ADDENDUM NO. 002 (Rev 01/2017)

ISSUE DATE: **03/12/2024**

RE: **GRAINGER HALL 2ND & 5TH FLOOR RENOVATION
PHASE 2 - 5TH FLOOR OFFICE RENOVATION &
PHASE 3 - 2ND FLOOR NW CORNER RENOVATION
UNIVERSITY OF WISCONSIN-MADISON
610 WALNUT STREET
MADISON, WISCONSIN**

UWSA Project No. **A-22-021**
UW Madison Project No. **0140-2303**

Graphic Scale	VARIABLE
PRJ. Number	UW: MSN 0140-2303 UWSA: A-22-021
Set Type	BD
Date Issued	02/20/2024
Sheet Number	A201

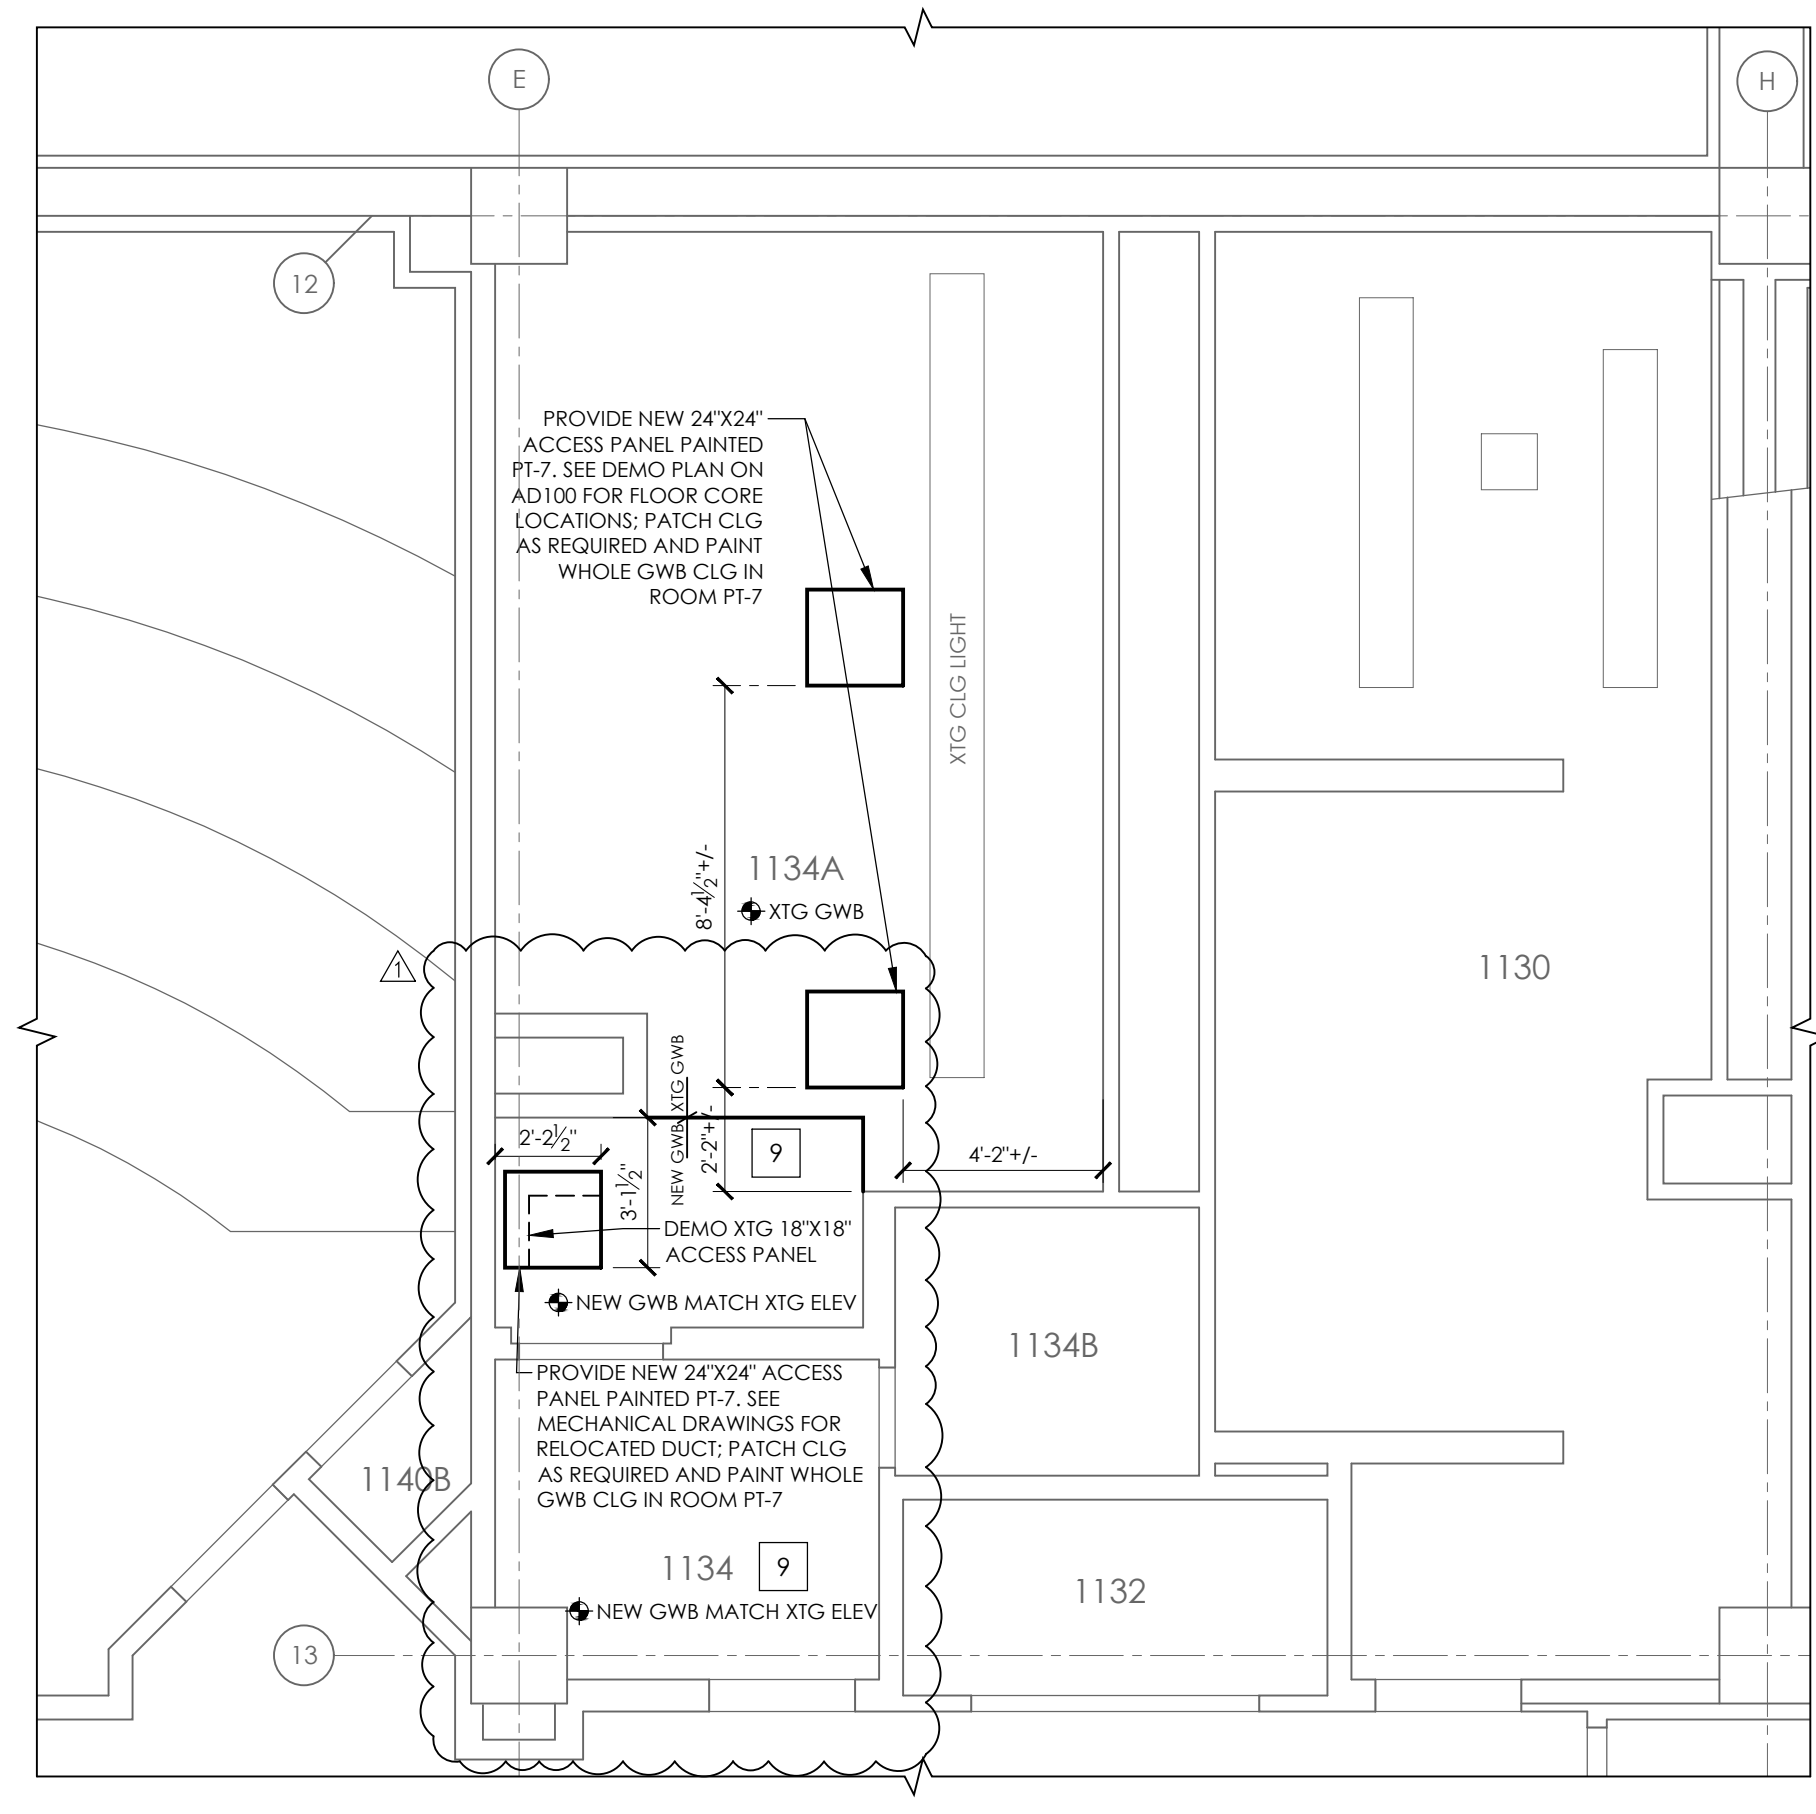
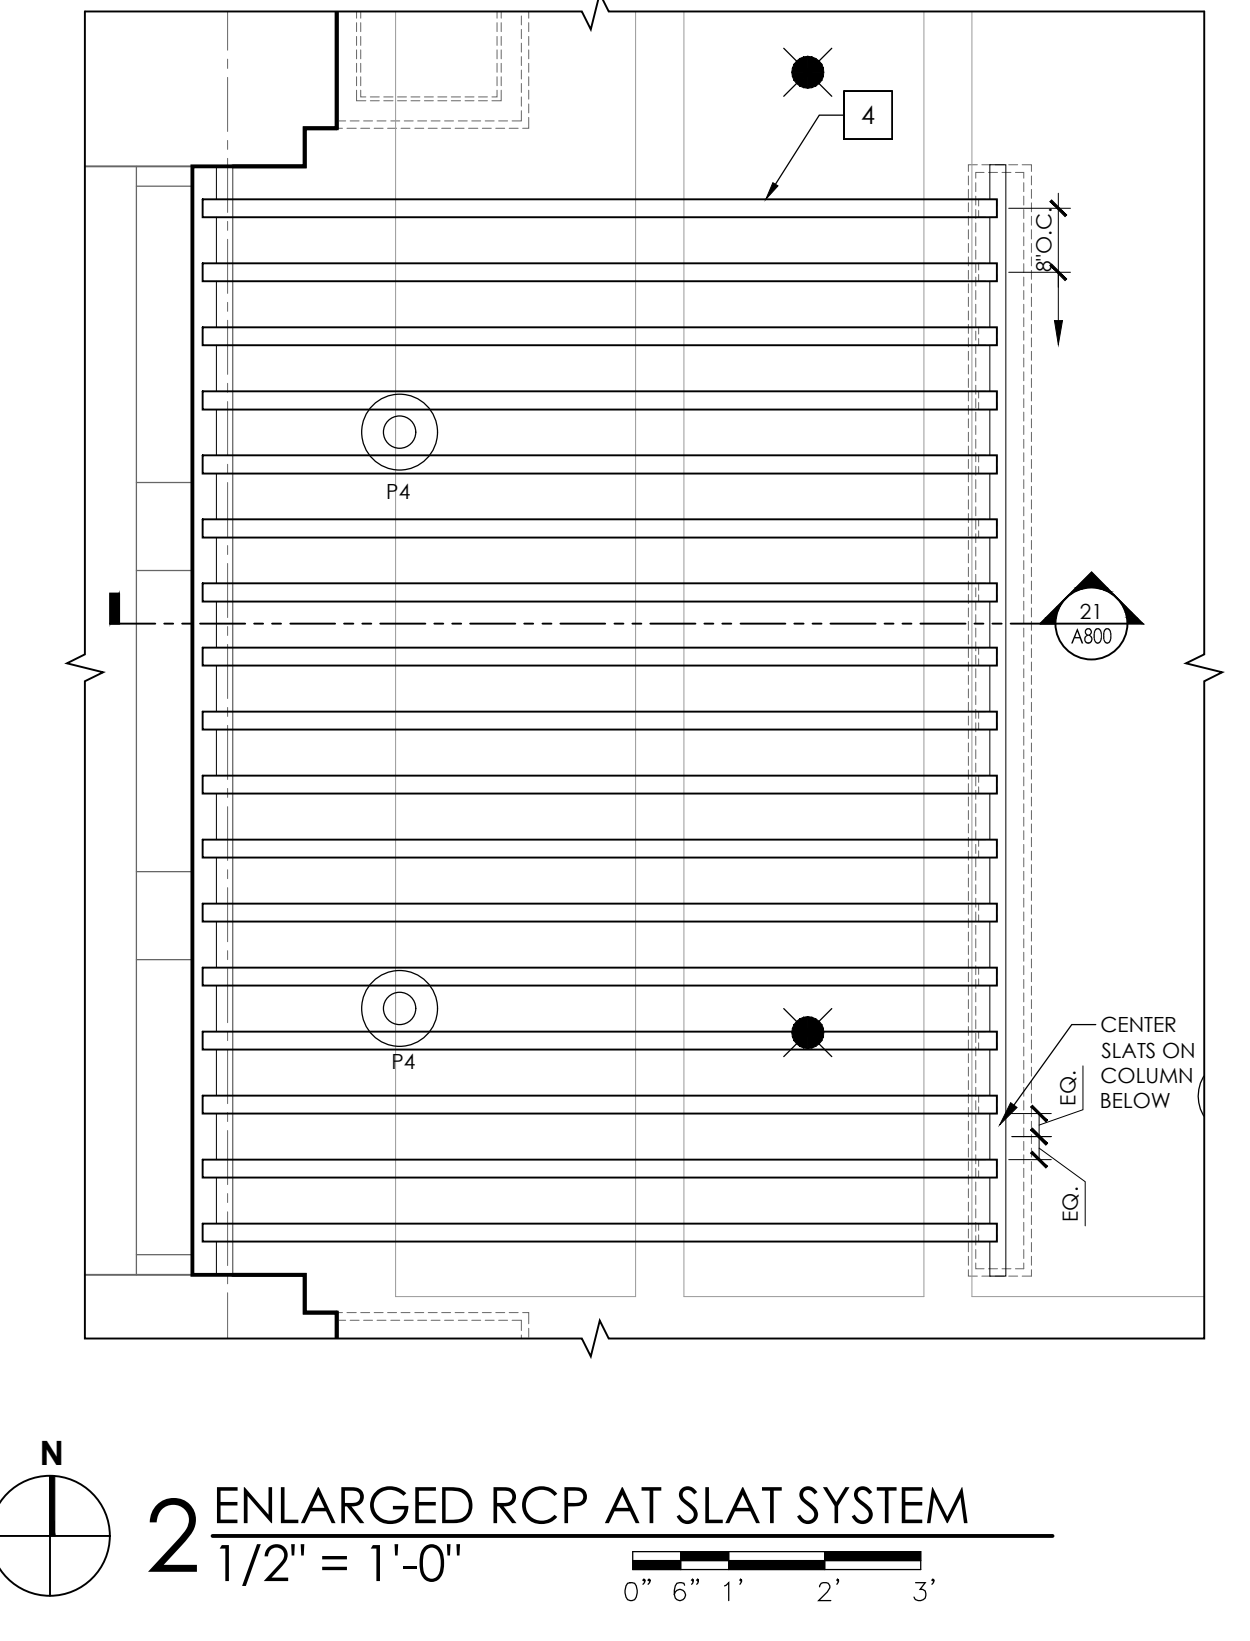
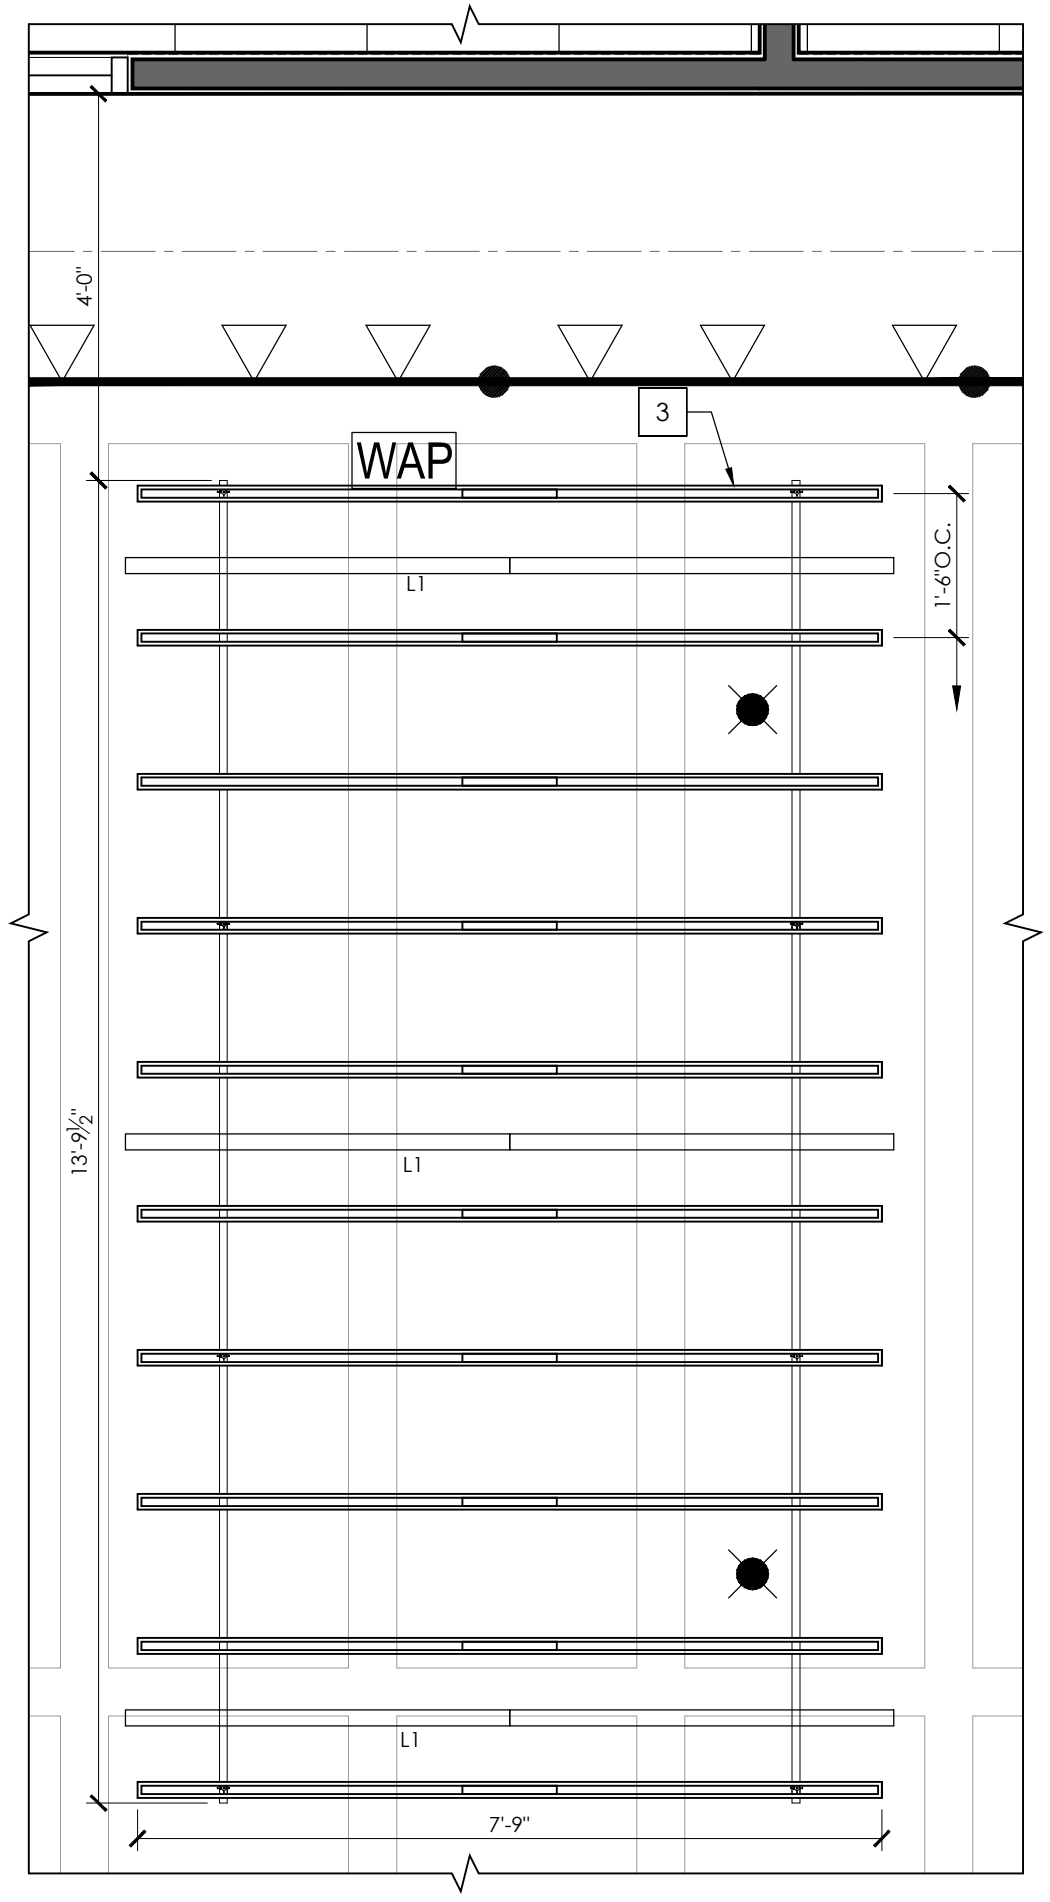
- a. Sheet A201.
 - i. **ADD:** Add keynote 9. Keynote to read, " GPC to demo the GWB ceiling as needed for the above ceiling plumbing and mechanical work. GPC to install GWB and paint the entire ceiling PT-7." See Sheet A201.

- AS-1 SUSPENDED FROM EXPOSED CLG 9'-4" A.F.F
- AS-2 SUSPENDED FROM EXPOSED CLG 9'-4" A.F.F
- AS-3 SUSPENDED FROM EXPOSED CLG 8'-7" A.F.F
- SLAT SYSTEM. SEE ASSOCIATED INTERIOR ELEVATIONS AND DETAILS
- RECESSED PROJECTOR. SEE ASSOCIATED DETAIL
- REPAIR XTG GWB SOFFIT. PAINT GWB PT-11 AND MATCH GWB TEXTURE OF XTG SOFFIT
- GWB AT COVE LIGHT CONDITIONS IN ROOM TO BE PAINTED PT-6
- NEW GWB AT XTG FRAMING PAINTED PT-4
- GPC TO DEMO THE GWB CEILING AS NEEDED FOR THE ABOVE CEILING PLUMBING AND MECHANICAL WORK. GPC TO INSTALL NEW GWB AND PAINT THE ENTIRE CEILING PT-7.
